Snow Engines

Affected Models: 690-WU, 690-WUA, 690-WUB, 690-WUC, 683-WU, 683-WUA, 683-WUB

Subject: Heat Shield Installation Informational Only

Subject: Heat Shield 751-19189

Figure 1

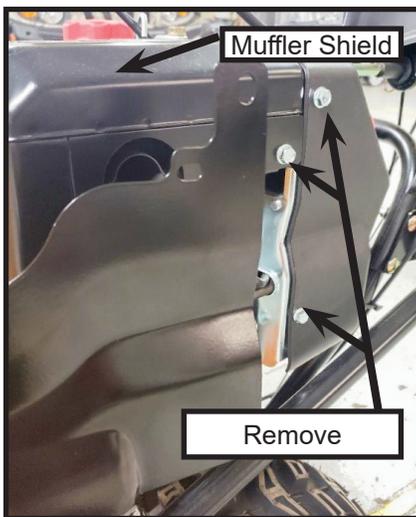
1. Park on a firm flat surface.
2. Allow engine to cool to room temperature.
3. Remove the Breather Hose from the Valve Cover to check for water or ice and let drain.
4. Reinstall Breather Hose.
5. Remove and Retain three M6 Muffler Shield Screws. See Figure 1.
6. Maneuver and Align the slots of Heat Shield **751P19088** into the Left Hand side of the Muffler Shield as shown in Figure 2.
7. Match up the mounting orifice and reinstall three M6 Muffler Shield Screws (Torque to 110-120 In. Lbs.). See Figure 3.

Figure 1

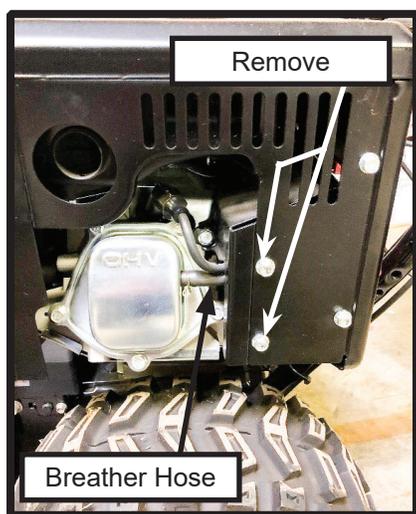
1. Park on a firm flat surface.
2. Allow engine to cool to room temperature.
3. Remove the Breather Hose from the Valve Cover to check for water and ice, let drain.
4. Reinstall Breather Hose.
5. Remove two M6 Muffler Shield Screws and Retain. See Figure 1.
6. Maneuver and Align the slots and orifice of **751-19189** into the Left Hand side of the muffler shield as shown in Figure 2.
7. Match up the mounting orifice and reinstall two M6 Muffler Shield Screws (Torque to 110-120 In. Lbs.). See Figure 3.
